MONTANA DEPARTMENT OF ENVIRONMENTAL QUALITY  
HARD ROCK MINING BUREAU  
OPERATING PERMIT – FIELD INSPECTION REPORT

Operator: Montana Resources, LLP				Inspection Date: July 18, 2022			
Operating Permit #: 00030			Project: Montana Resources-Continental Mine Complex			County: Silver Bow	
Nearest City or Town(s): Butte							
DEQ Staff: Garrett Smith				Company Representative(s): Mark Thompson			
Agencies w/overlapping Jurisdiction:			USFS		BLM		Other <input checked="" type="checkbox"/> None
Minerals: Copper, molybdenum, minor silver							
Status:		<input checked="" type="checkbox"/>	Active		Inactive		Suspended <input type="checkbox"/> Other <input type="checkbox"/>
Weather: Mostly sunny, windy, high temp 82°F							
Type of Operation:				Purpose of Inspection:			
<input checked="" type="checkbox"/>	Open Pit				Initial (Pre-permitting)		
	Underground			<input checked="" type="checkbox"/>	Regular Compliance		
	Placer				Amendment #		
<input checked="" type="checkbox"/>	<i>Heap Leach- Leach pads near HSB no longer receiving solution</i>				Complaint Received

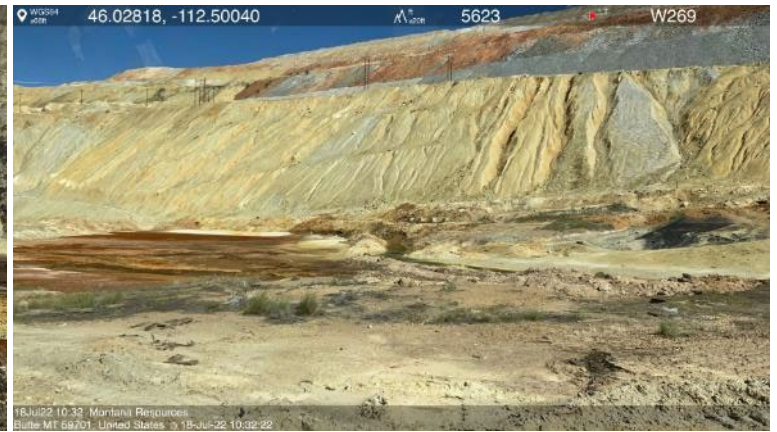
On June 14, 2022, MR submitted a permit modification application to DEQ to allow the construction of a rock disposal site (RDS) within the HSB area, at the southern toe of the YDTI (Photo 1). The feature would include a foundation drainage layer and engineered rock drains to capture and convey seepage flows from underneath the RDS, eventually reaching the management and treatment systems required under the Superfund remedy. Reclamation of the RDS would involve grading the surface to a stable slope, covering with soil, and reseeded. The designs for the RDS and underlying drainage system were certified by the designated Engineer of Record (EOR). Even though the project does not constitute an expansion of a tailings storage facility (as defined in 82-4-303, MCA), the Independent Review Panel (IRP) for the YDTI also reviewed the project plans and provided supportive feedback.

area” footprint of 73 acres within the permit boundary. The approved permit modification for the HSB RDS requires demolition of the old Precipitation Plant, thus eliminating the pre-1971 processing facility that retained the exempt status (Photo 7). The exemption from permitting and bonding requirements would no longer apply to the area, as the remaining buildings and infrastructure are not processing facilities. **The obligated bond required for the permit modification is \$36,500 (73 acres x \$500/acre), consistent with the bonding level for pre-1974 disturbance areas surrounding the HSB. Pending an adjustment of the obligated bond amount held by DEQ, the approved amendment allows MR to proceed with the activities associated with the construction and eventual reclamation of the HSB RDS.**

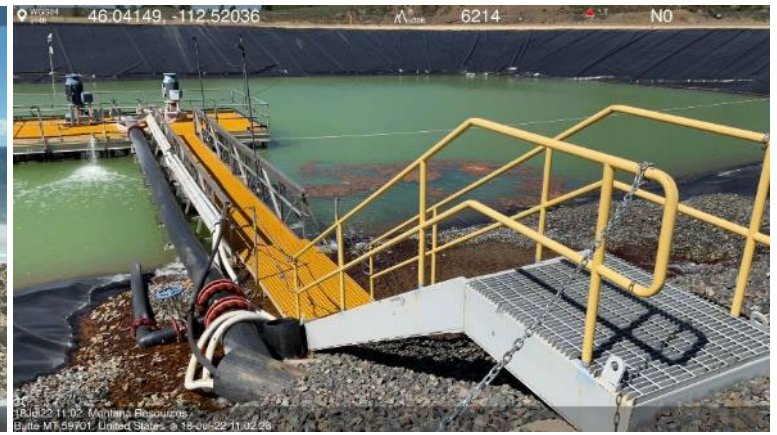
MR submitted a request for permit revision MR22-001 on April 13, 2022 to construct a new Precipitation Plant, approximately 0.5 mile to the south of the old plant within HSB. DEQ provided a deficiency letter on May 3, 2022 with questions about the construction, operation, and reclamation of the plant, as well as the location of the plant in relation to pre-1974 disturbance areas. MR has not responded to the deficiency comments at the time of this inspection, although construction of concrete structures and foundations at the new facility have progressed beyond the ground preparation that was observed on the June 7, 2022 site inspection (Photos 8 and 9).

The new plant location is no longer within the exempt HSB footprint, it is located on previously disturbed ground where no structures exist in the currently approved permit. **Although the precipitation process would continue in a similar manner at the relocated plant, an entirely new facility constructed in a new location constitutes a change to the details of the approved Operations and Reclamation plans. Additional bond may also be required to address reclamation for portions of the facility that occur outside of the pre-1974 disturbance area (82-4-338, MCA and ARM 17.24.141). DEQ contacted MR on July 19, 2022 and explained that this activity is considered a violation of 82-4-336(4), MCA, for departing from an approved plan without obtaining department approval for the proposed change. DEQ will soon provide additional correspondence regarding this noncompliance.**

- Precipitation Plant Relocation- Application for permit revision was submitted on April 13, 2022. Responses are pending from MR to the deficiency comments DEQ provided on May 3, 2022. Construction of the new plant has continued without DEQ’s authorization, and potentially without being adequately bonded. DEQ will provided additional correspondence about noncompliance.
